Sample Document Review Report

Commercial Interior Renovation

Full Document Review

06. REDLINED SHEET SAMPLE

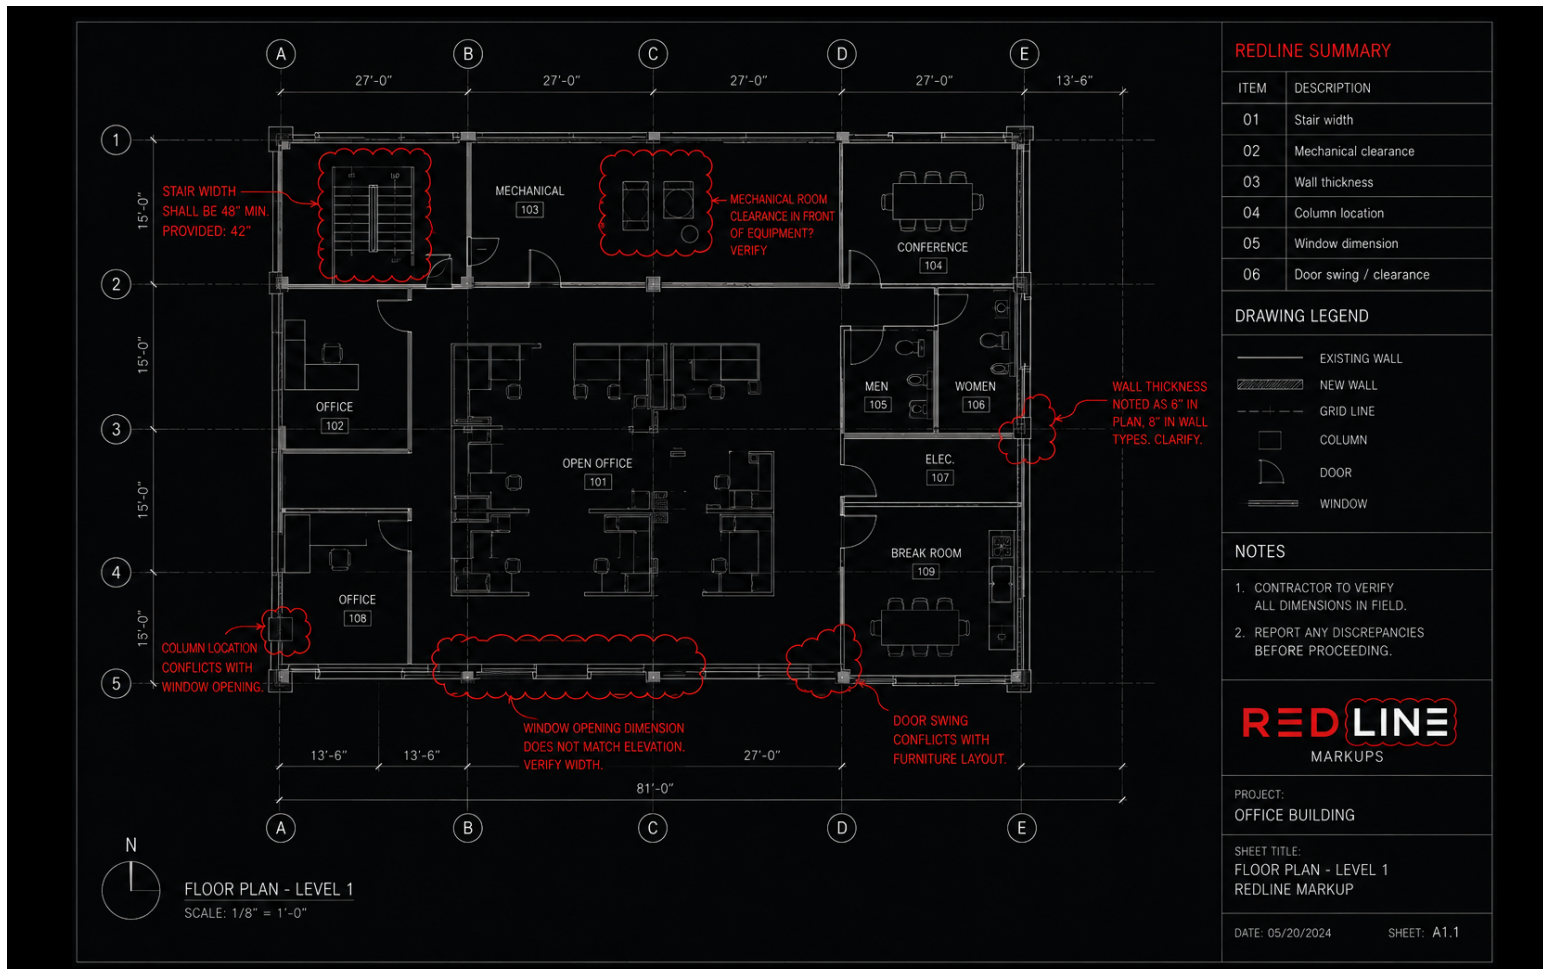
R-001
Mechanical duct conflict with structural beam.

R-004
Door tag missing from schedule.

R-006
Ceiling clearance conflict at corridor transition.

R-007
Outlet location conflicts with millwork elevation.
